Safety Recall Campaign 4009
SC-77

Safety Recall Campaign 4009 Power Steering Tensioner Pulley

Affected Models: Certain 2006 Grand Vitara Models

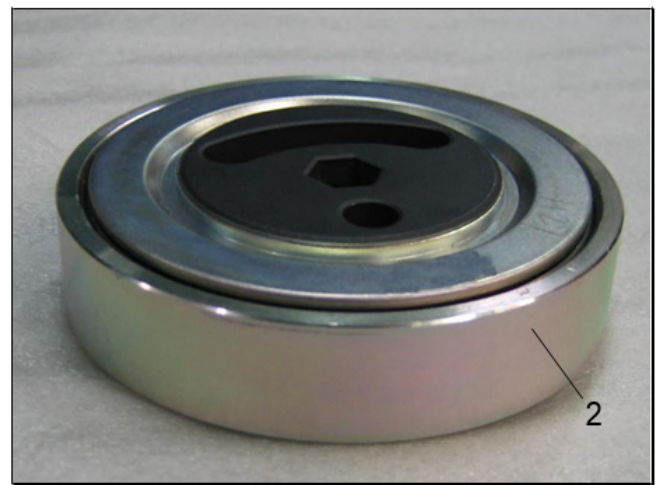
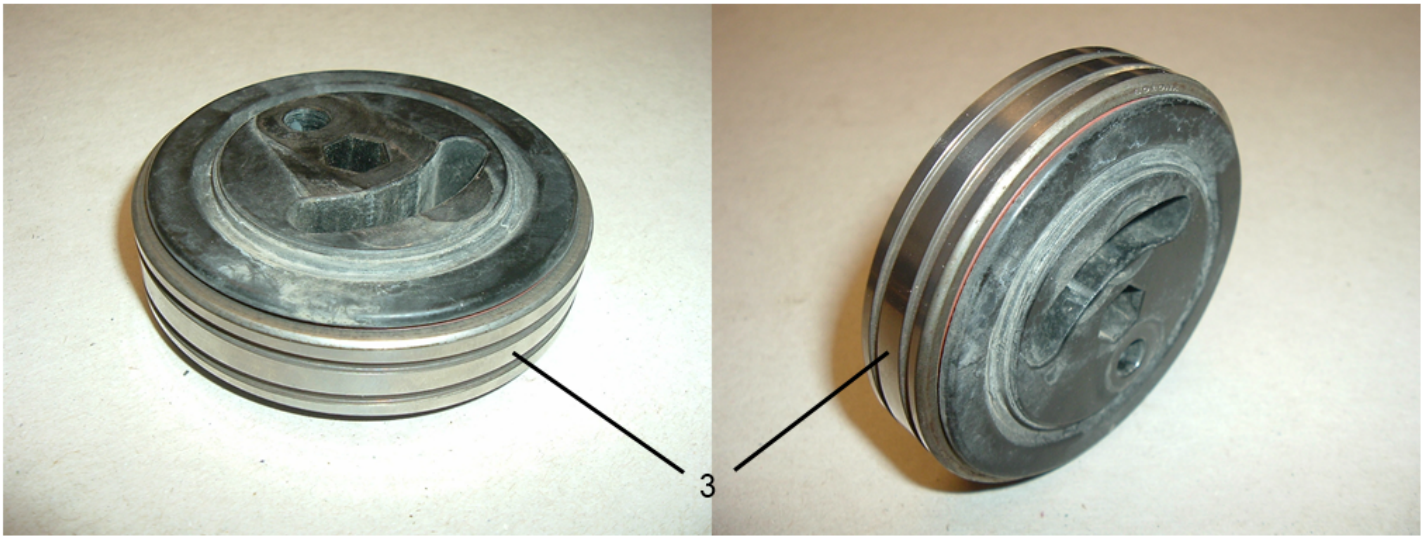
- 2) Visually check the tensioner pulley (1) outer race to determine if it is plastic or steel.

- 3) You can easily identify if it is plastic or steel by the color of the outer race.

Black: Plastic Outer Race (1)
Replace

Silver: Smooth Steel Outer Race (2)
Do Not Replace

Failed: Black plastic outer race is missing (3)
Replace

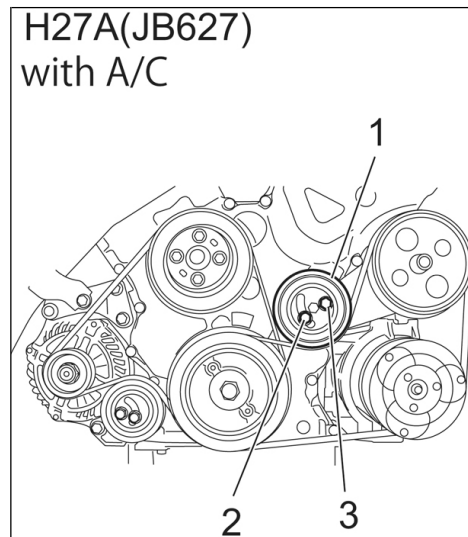
- 4) Remove the plastic tensioner pulley (1) from the engine:

Loosen the tensioner pulley adjusting bolt (2) to relieve the tension on the power steering/AC belt, and remove it along with the tensioner pulley bolt (3). Then remove the tensioner pulley.

- 5) Install the new steel tensioner pulley, tensioner pulley bolt (3) and adjuster bolt, and tighten it by hand.

Belt Tension Method

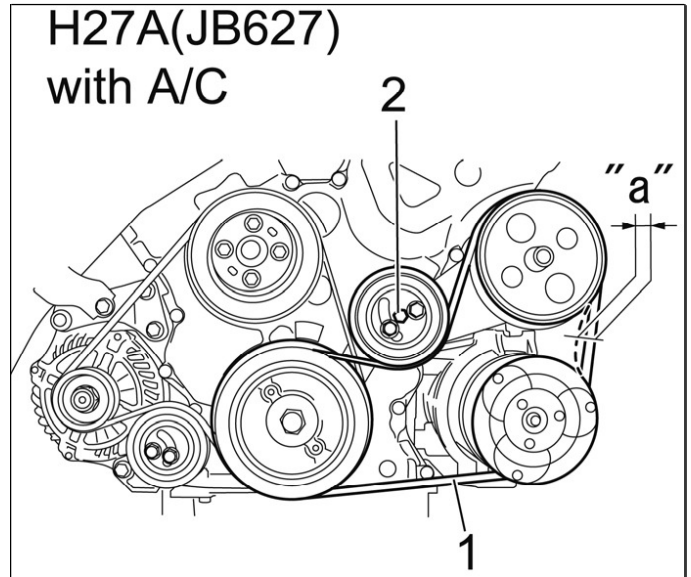
- 6) Insert the 10mm hex wrench in the hexagonal hole (2) on the pulley and turn it counterclockwise, increasing the tension of the belt until "a" reaches the deflection value listed below. Then temporarily tighten the adjusting bolt and pulley bolt.

5 - 6mm (0.19 - 0.23 in)

5.5 - 6.5mm (0.21 - 0.25 in)

Measuring condition: When pushing on the belt at the center point between the pulleys with 100N (22.5 lbf-ft) of force as shown to the right.

Sonic Tension Method

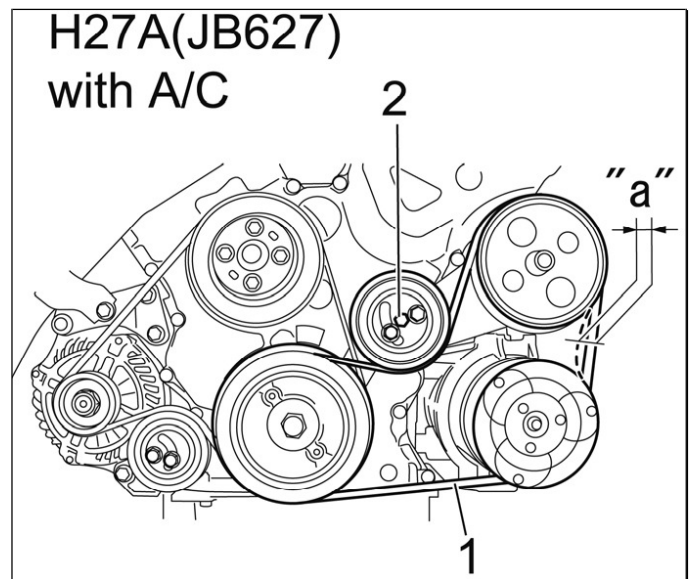
- 7) Set the sonic tension meter to the following frequency filter values:

Insert the 10mm hex tool in the hexagonal hole (2) on the pulley and turn it counterclockwise to increase or clockwise to decrease the tension on the belt to obtain the specified value shown below. Then temporarily tighten the adjusting bolt and pulley bolt.

Using a new belt: 500 ± N

Readjustment: 400 ± N

Torque Method

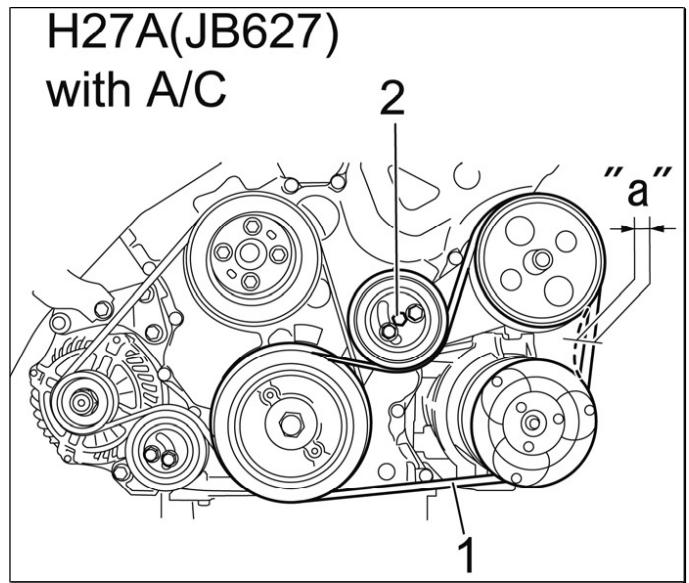
- Using the 10mm hex socket, insert the 10mm hex tool in the hexagonal hole on the pulley and turn it counterclockwise to increase the tension until you obtain the specified torque value as shown below. Then temporarily tighten the adjusting bolt and pulley bolt.

Using a new belt:
17 N·m (12.5 lbf-ft)

Readjustment:
12 N·m (9.0 lbf-ft)
